**DEVIATION REQUEST  
AND DECISION FORM**

Project Name : Latigo Filing 10  
 Schedule No.(s) : 4200000352  
 Legal Description : SEE ATTACHED – Exhibit C

A deviation from the standards of or in Section **ECM section 3.3.7 Permanent Storm Water Management Facilities** of the Engineering Criteria Manual (ECM) is requested for the proposed Temporary "Full Infiltration Treatment Control Pond".

Table - Node BS\_F9\_InterimPond

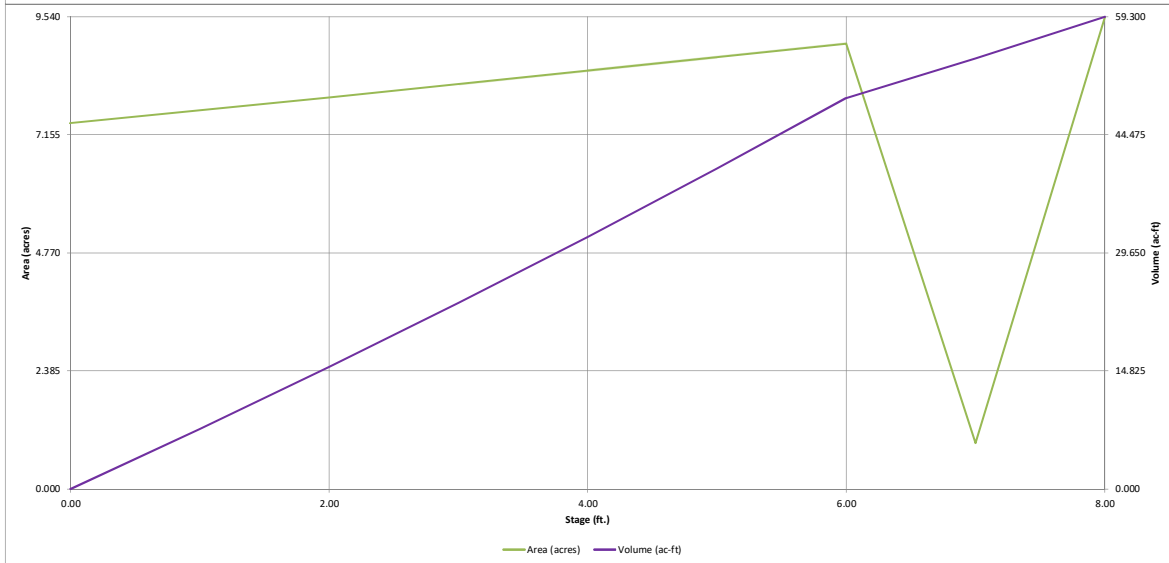
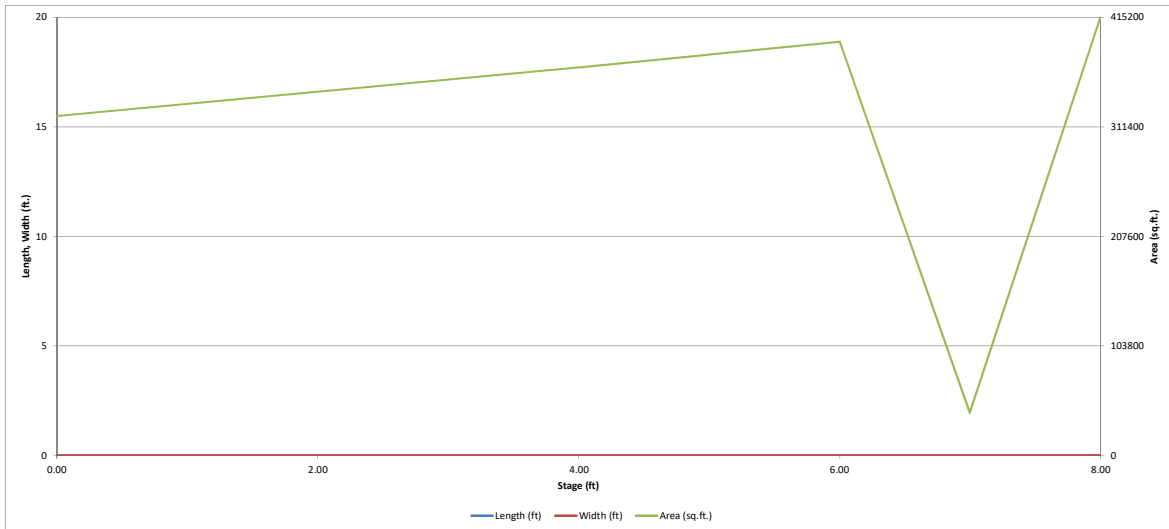
Explain how the SWMM model accounts for infiltration rates. Include the input variables used to generate the results provided.
